Community and Stakeholder Engagement Report

Addiscombe Road and Kenneth Road, Manly Vale – Shared Path and Pedestrian Crossing Upgrade

Additional pram ramp required on Addiscombe Rd between 5 Fairway Close and Fairway Reserve:

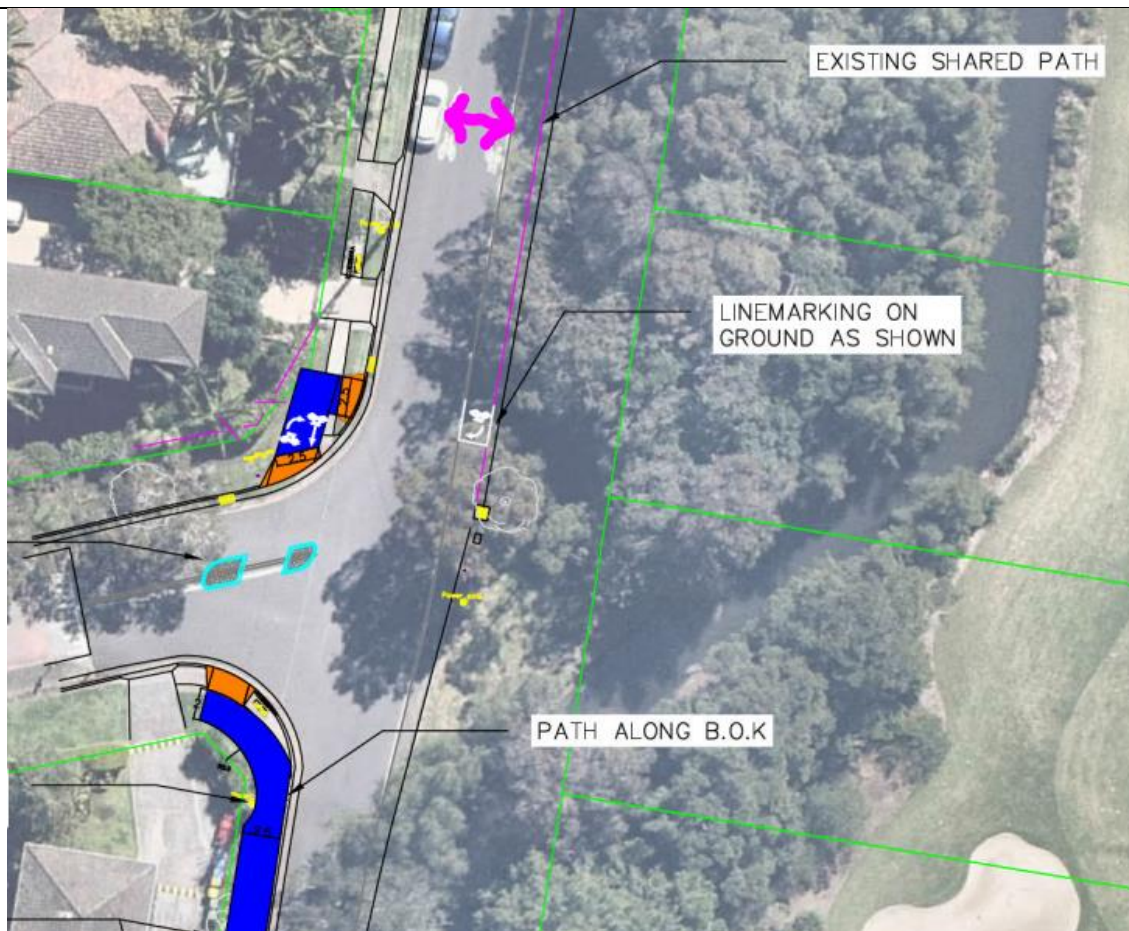
- If travelling north along the existing shared path, there needs to be a new pram ramp option to get onto the new shared path for bicycles, wheelchairs and prams via a new pram ramp. Otherwise these users will have to turnaround to go back to the Kenneth Road intersection, or use Addiscombe Road and share with vehicles which is obviously not the safest option. Again, not aligned to the accessibility and safety objectives of the Transport Strategy.

Pathway extension along northern section of Fairway Close to connect to proposed shared path:

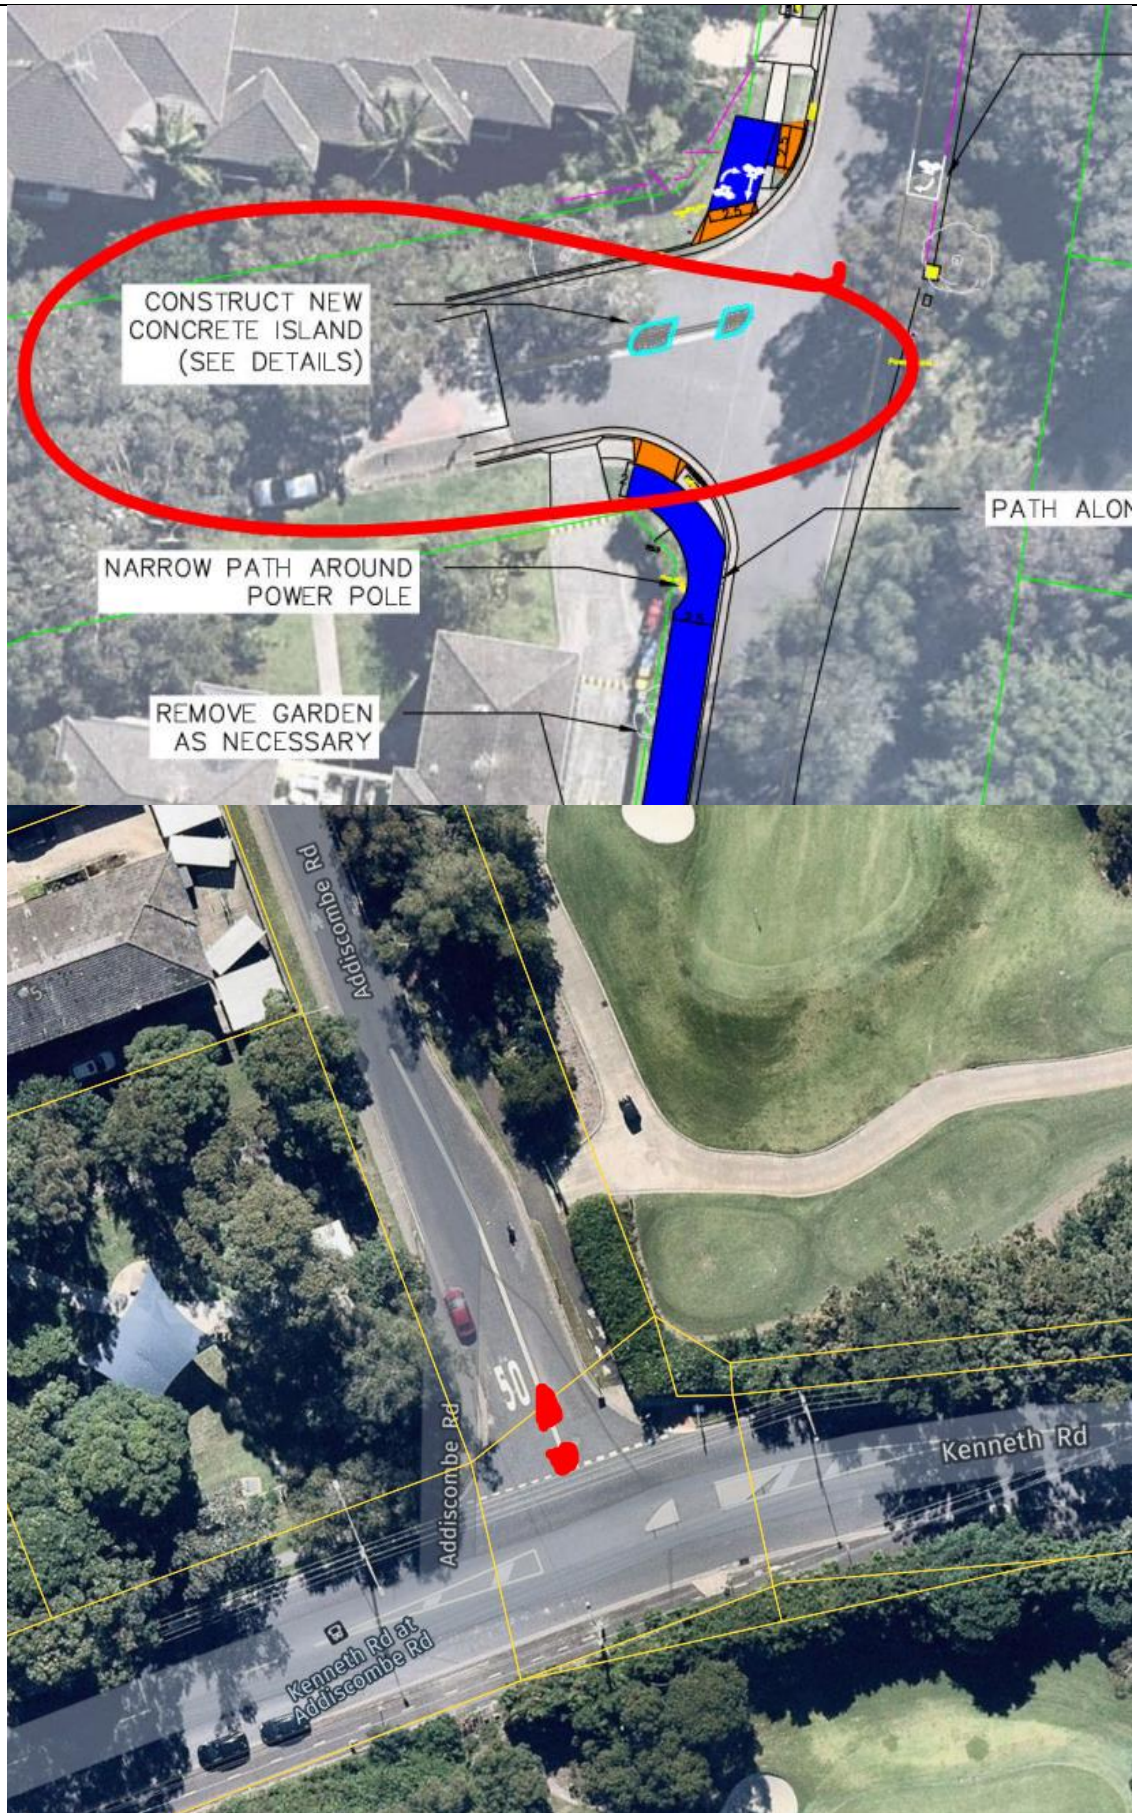
- Limited accessibility for bicycles, prams and disabled users to the new shared path from Fairway Close residences and even difficult access for pedestrians in wet weather. This is due to no concrete pathways in Fairway Close, inadequate nature strips for prams and disabled users on the northern section of Fairway Close, combined with a blind spot on the bend and in Fairway Close. Due to the inadequate connectivity, prams, pedestrians and cyclists are forced to walk on the road in this location.
- Recommend extending the footpath at least until the bend on the northern nature strip for connectivity, accessibility and safety.

Widen proposed shared path with a slight shift of the Council shed:

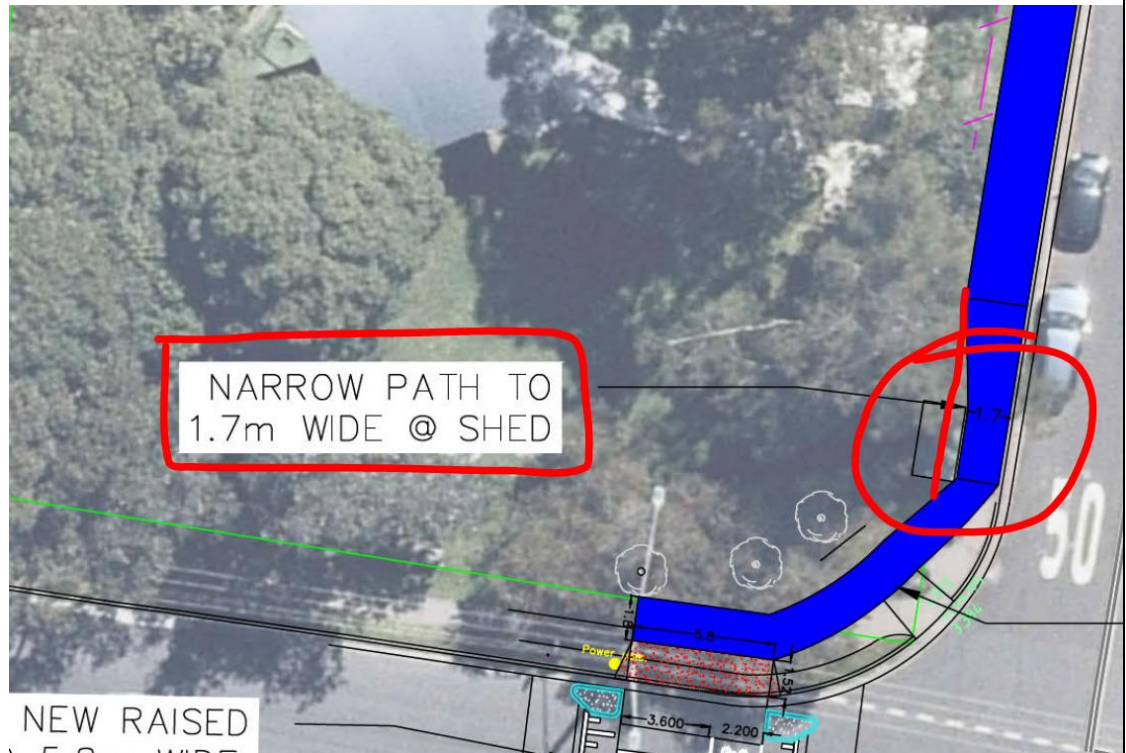
- No need to create an unsafe narrow section of path right at the intersection of Kenneth Road. Narrowing the path in this location is unnecessary when there is plenty of room to shift the shed towards Fairway Reserve. A newly planned path can accommodate the full width of a shared path at this location and should not be compromised because of Council's recent placement of this shed.
